**ADDENDUM NO. 1
NEW ELEVATOR
AT MURPHY ELEMENTARY SCHOOL
ROUND LAKE SCHOOL DISTRICT NO. 116
PROJECT NO. 23170**

Board of Education
Round Lake School District 116
884 West Nippersink Road
Round Lake, Illinois 60073

HV0.1

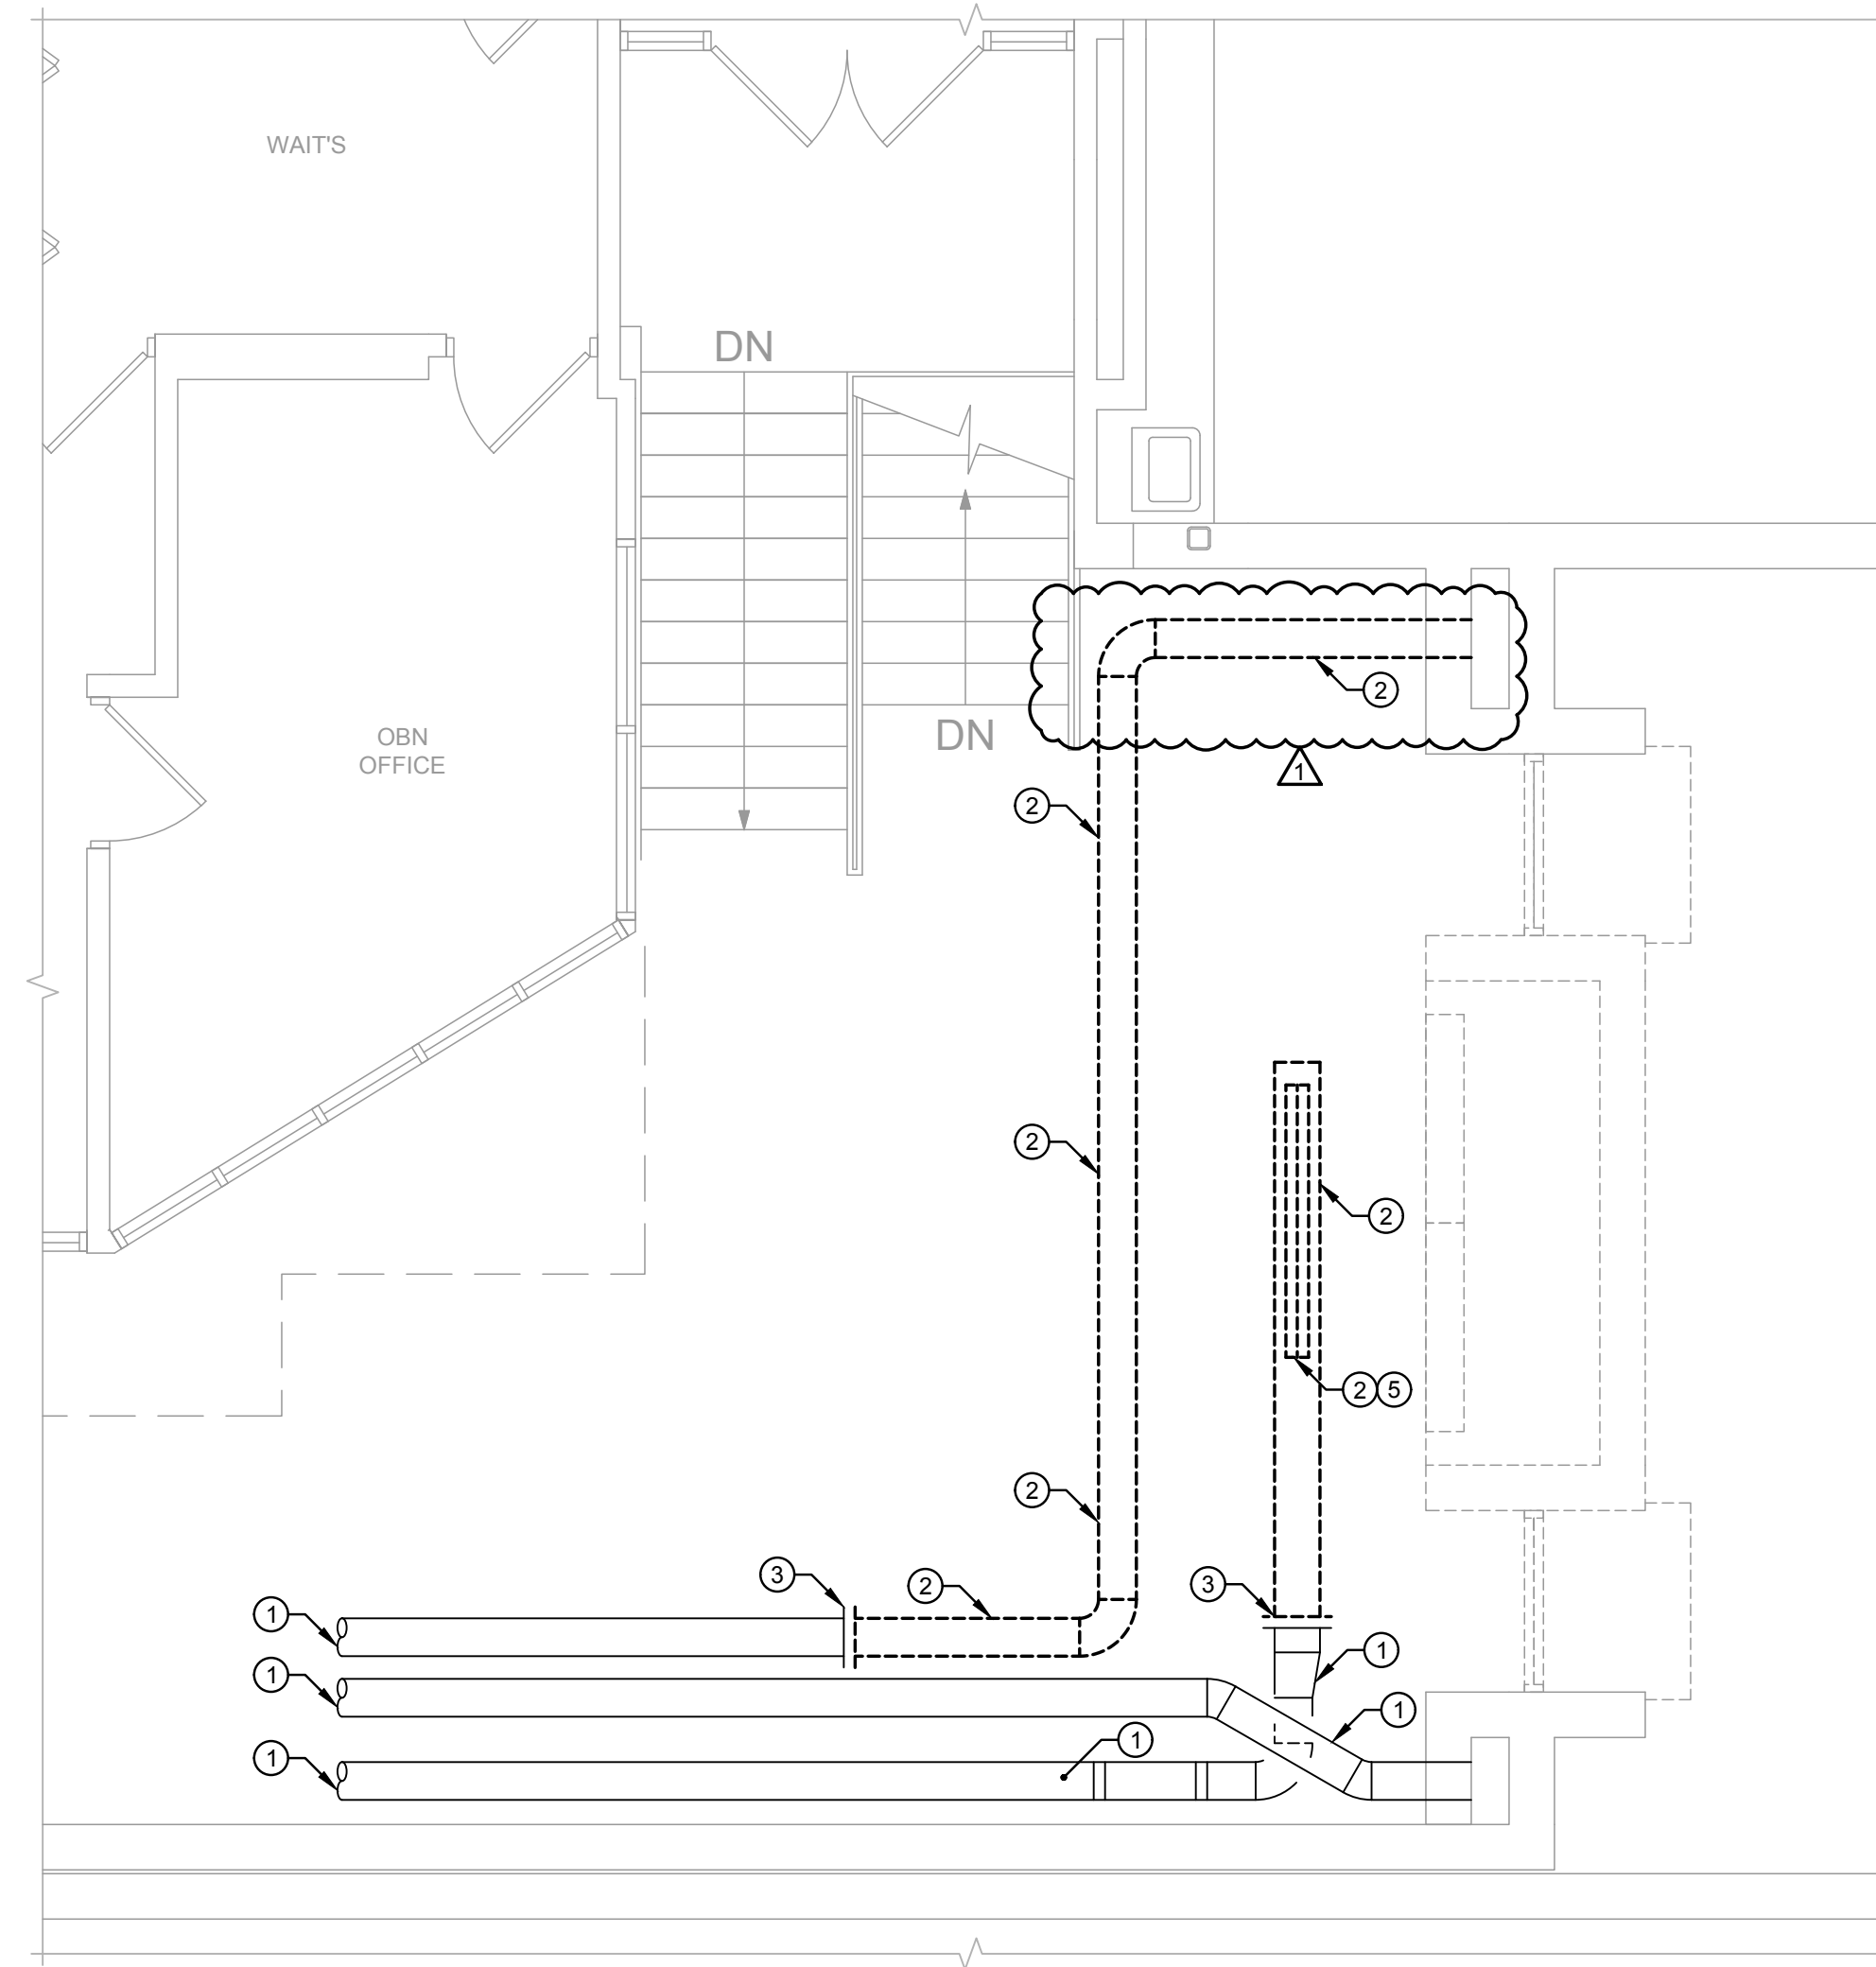
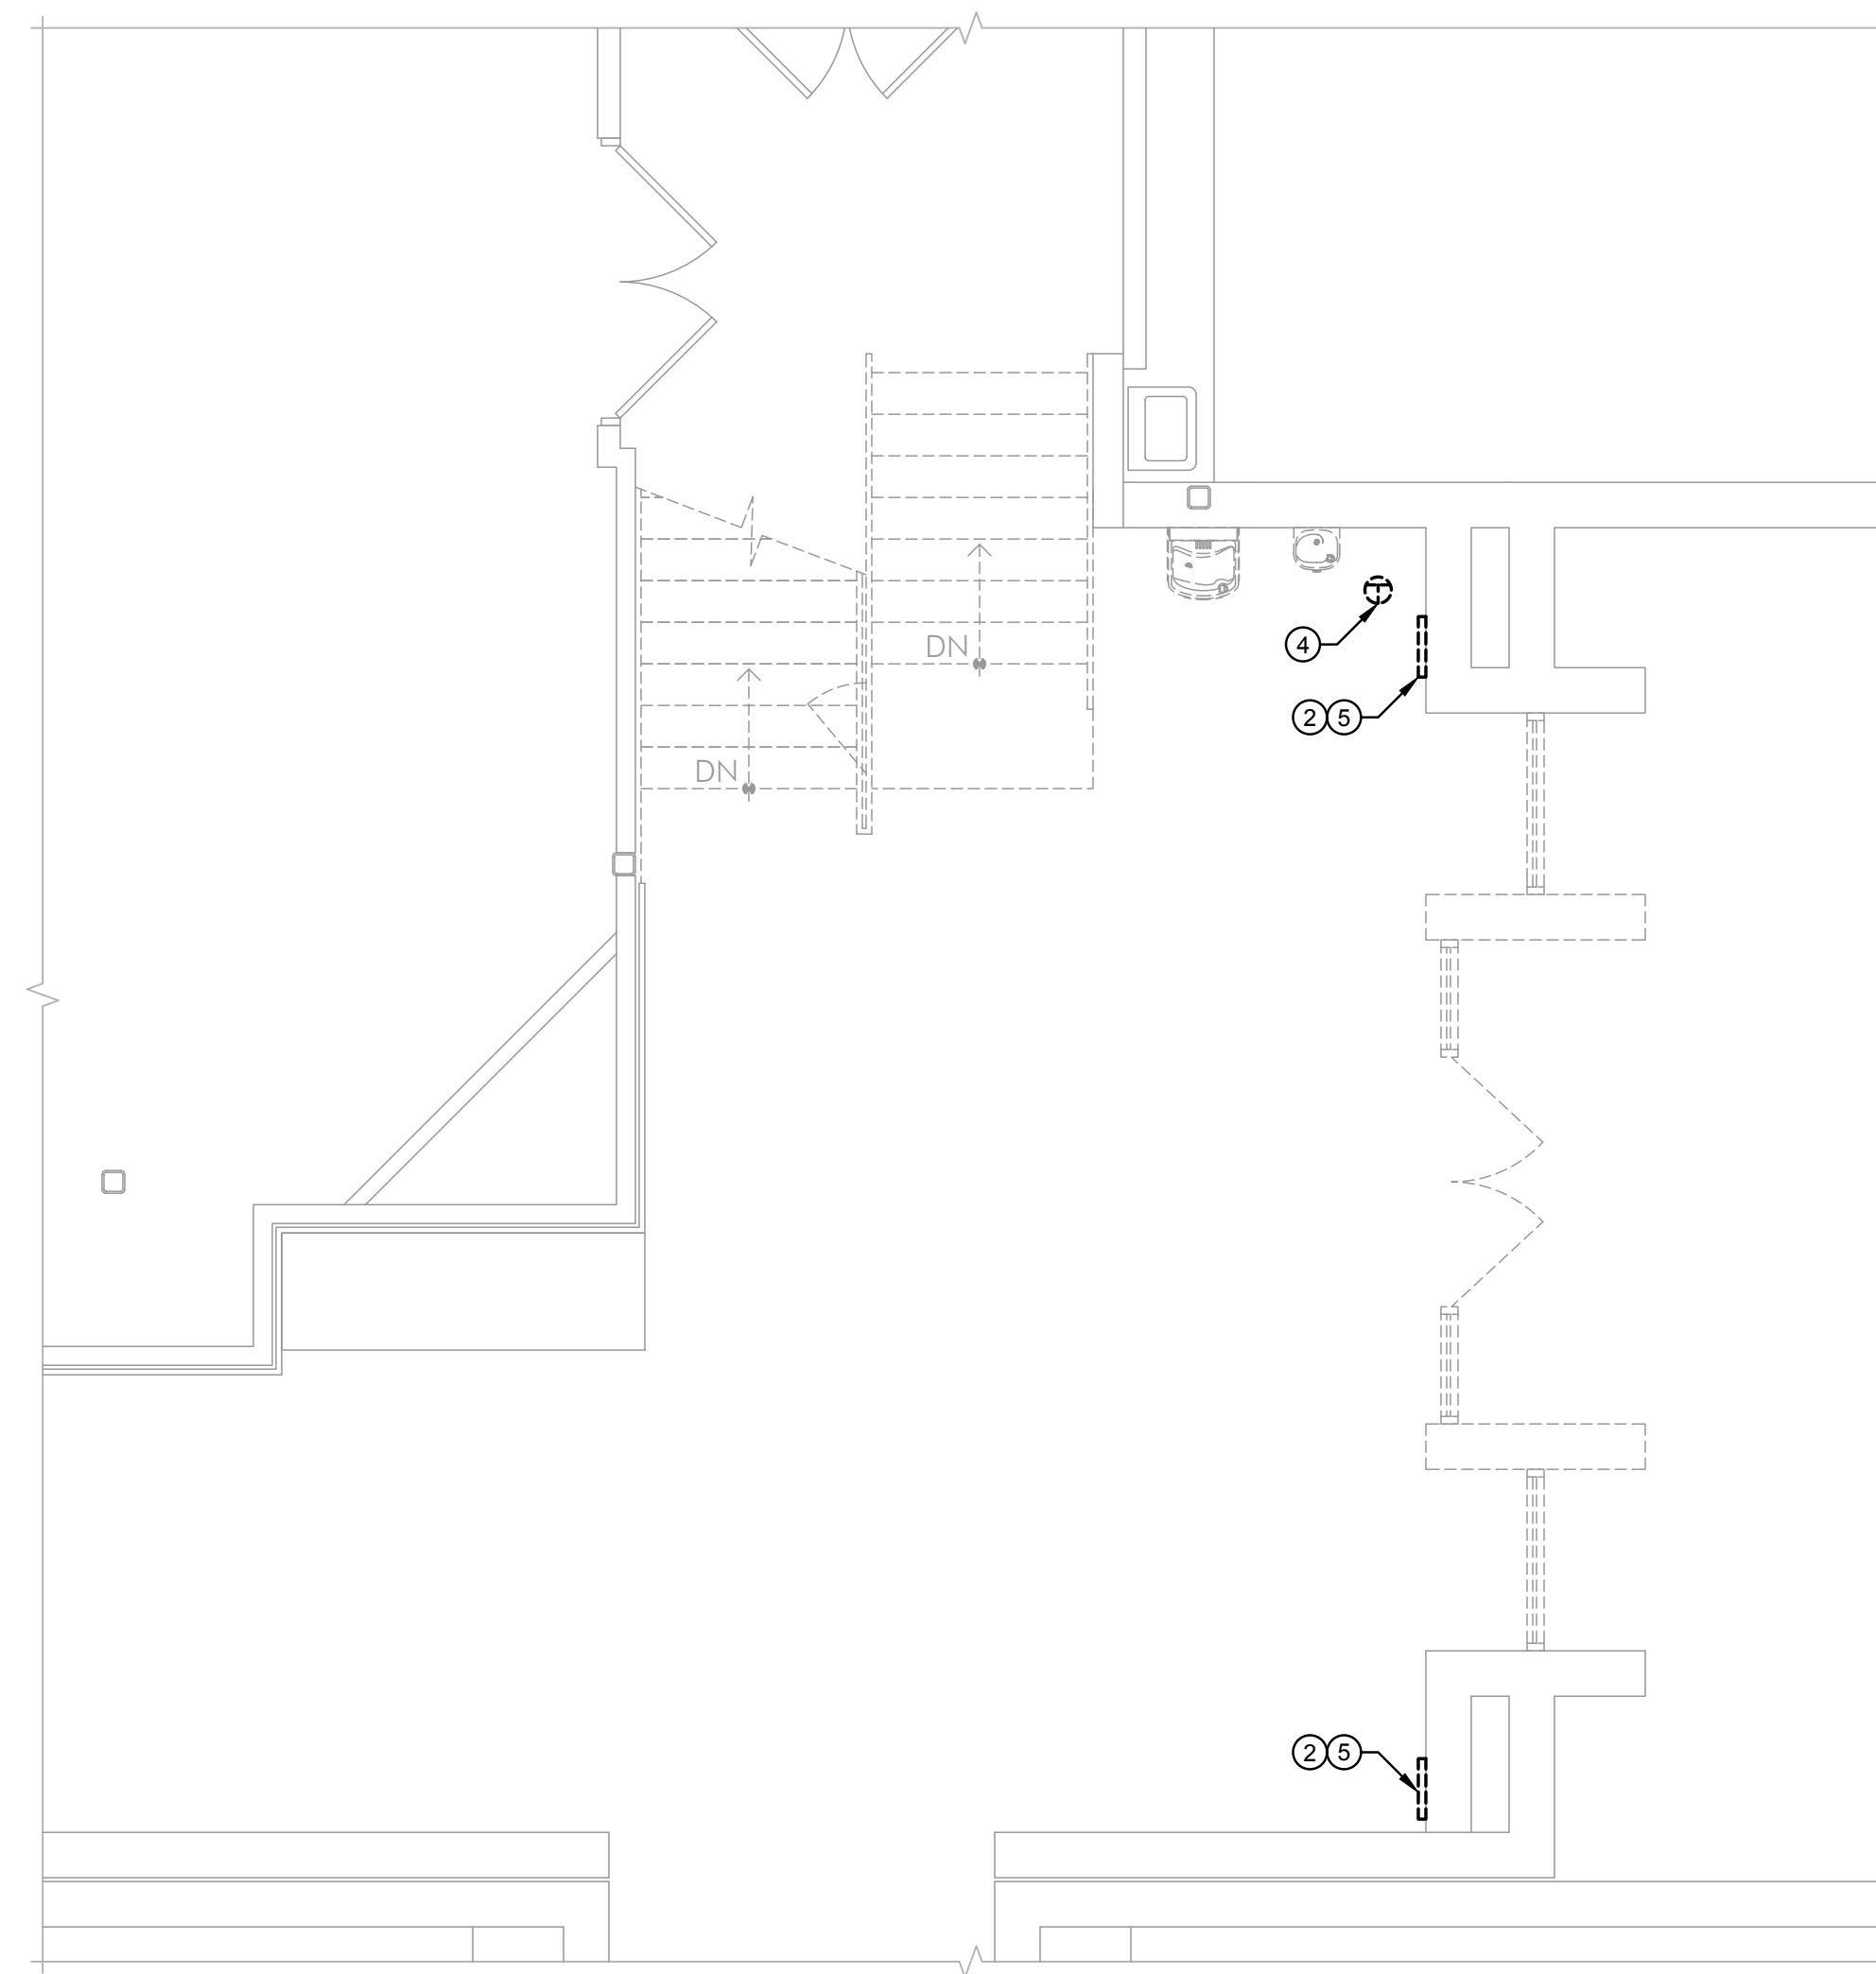
ITEM NO. 6: PROJECT DRAWINGS, HVO.1, PARTIAL HVAC DEMOLITION PLANS

1. Refer to attached drawing HVO.1 and refer to highlighted items for updates.
